**ITEM 5. DEVELOPMENT APPLICATION: 111-139 DARLINGHURST ROAD POTTS POINT****FILE NO: D/2013/1747****DEVELOPMENT APPLICATION NO: D/2013/1747****SUMMARY****Date of Submission:** 12 November 2013**Applicant:** IRIS Capitol**Architect:** SJB Architects**Cost of Works:** \$50,248,685**Proposal Summary:**

Stage 1 development application that seeks to establish a building envelope for a redevelopment of the site, formerly known as the Crest Hotel. It is envisioned that the site will accommodate a mixed use development comprising residential units within a 14 storey tower over a 5 storey podium containing a mix of residential and commercial uses, with basement parking.

**Figure 20:** A minor exceedance of the 55m height plane exists at the southern end of the proposed building envelope. Any exceedance of the 55m height limit is not supported

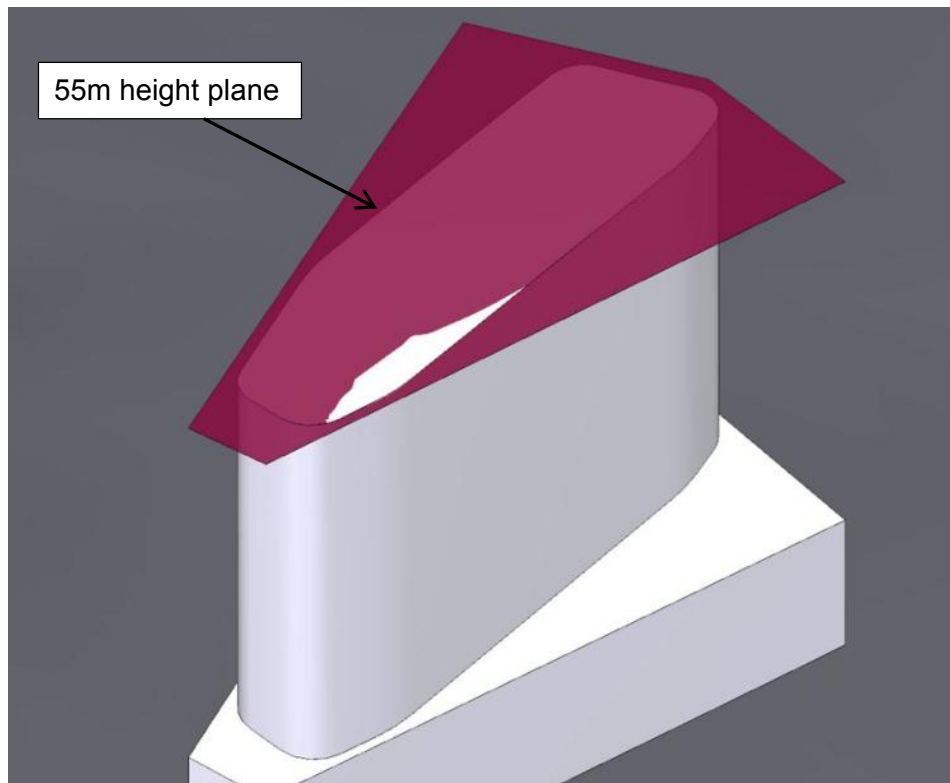
58. The proposed building envelope generally complies with the maximum building height of 55m contained in Sydney LEP 2012, however there is a small area at the southern end of the tower which exceeds the height limit by approximately 200mm (refer to Figure 20).
59. Any exceedance of the maximum height limit is not supported and a condition of consent has been recommended to require the building envelope to be amended so that it does not exceed 55m at any point.

Prior to the endorsement of any competition brief relating to the site, the building envelope must be amended so that no part of the envelope exceeds the 55m height limit, and provided to competition participants.

**Figure 21:** Building envelope viewed from the south showing the existing podium (shaded) and the proposed increase to 5 create a storey podium (indicated by the dotted line)

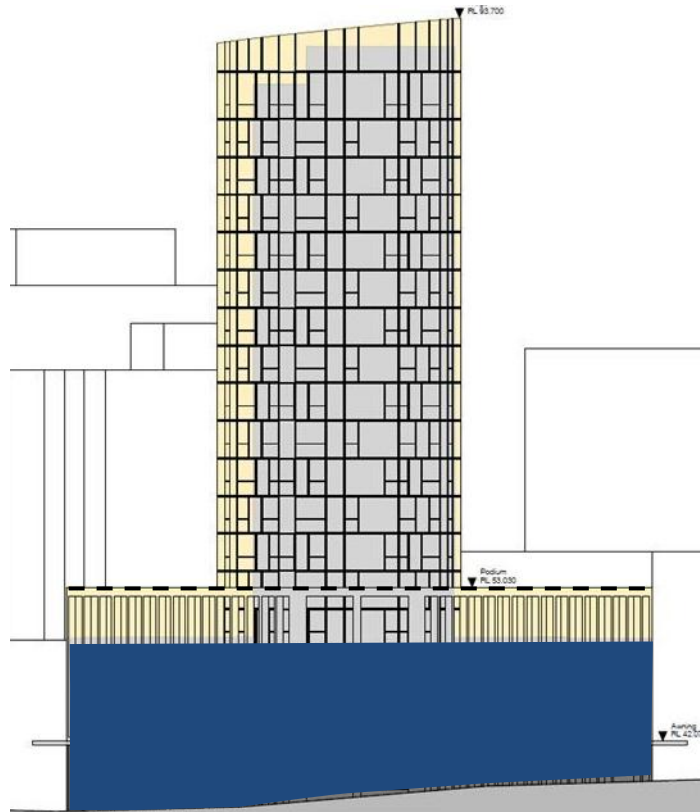
69. The proposed podium height would match the building height of the adjoining development at 107-109 Darlinghurst Road, and the podium height of a nearby development at 204 Victoria Street. Given the variation in the scale of surrounding development, the proposed podium height is not considered to result in adverse impacts on the streetscape, and is supported.
